Access Compliance Report

Public Rights-of-Way

Intersection ID: 8762	Main Street: ROWAN_ST	Cross Street: S_HOSKINS_RD	Location:	N
ADA ID: C938016A9263	Ramp Type: Perp	Initial Pass/Fail: Pass	Overall Compliance: No	Severity Score: 25
Codes/Mitigation Info/Possible Solution		Field Measurements/Component Compliance

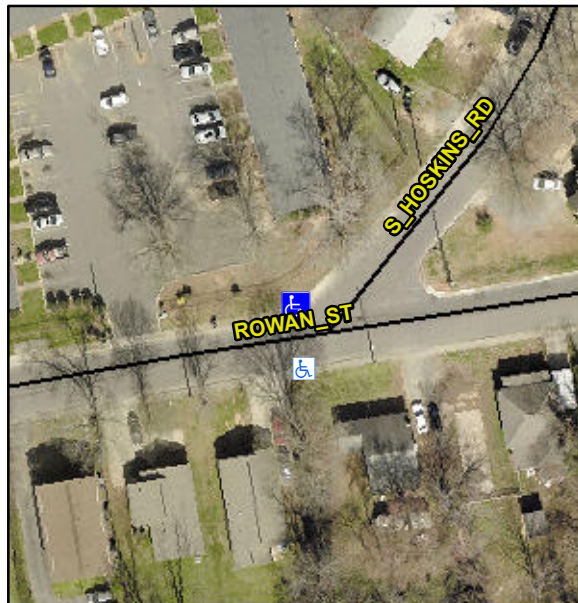
**Not Found, R304.2.1, R304.2.2-Perp,
R304.3.2-Para, R304.5.3, R304.2.3,
R302.7.2, R304.5.4**

Compliance	Description	Data	Compliance	Description	Data
N/A	Ramp Length (in)	48.0	Yes	Ramp Slope (%)	5.2
Yes	Ramp Width (in)	48.0	Yes	Ramp XSlope (%)	1.7
N/A	Flare Type LT	Sloped	N/A	Flare Type RT	N/A
N/A	Flare Slope LT (%)	10.3	Yes	Flare Slope RT (%)	5.7
N/A	Flare Traversable LT?	Yes	N/A	Flare Traversable RT?	Yes
No	Landing Length (in)	N/A	Yes	DWS Provided?	Yes
No	Landing Width (in)	N/A	Yes	DWS Contrast?	Yes
No	Landing Slope (%)	N/A	Yes	DWS Length (in)	24.0
No	Landing X Slope (%)	N/A	Yes	DWS Full Width?	Yes
N/A	Landing Curb? (Y/N)	No	Yes	DWS Offset (in)	0.0
N/A	Shared Landing?	No			
Yes	Gutter Ponding?	No	No	Gutter Slope (%)	5.4
No	Gutter Lip Ht (in)	0.5	Yes	Gutter X Slope (%)	1.8
N/A	Painted X Walk1?	No	N/A	Painted X Walk2?	N/A
	X Walk 1 Direction	To S		X Walk 2 Direction	N/A
N/A	X Walk 1 Width (in)	N/A	N/A	X Walk 2 Width (in)	N/A
	X Walk 1 Slope (%)	7.6		X Walk 2 Slope (%)	N/A
	X Walk 1 X Slope (%)	0.5		X Walk 2 X Slope (%)	N/A

**Remove & Replace Entire Ramp.
Remove & Replace Gutter.**
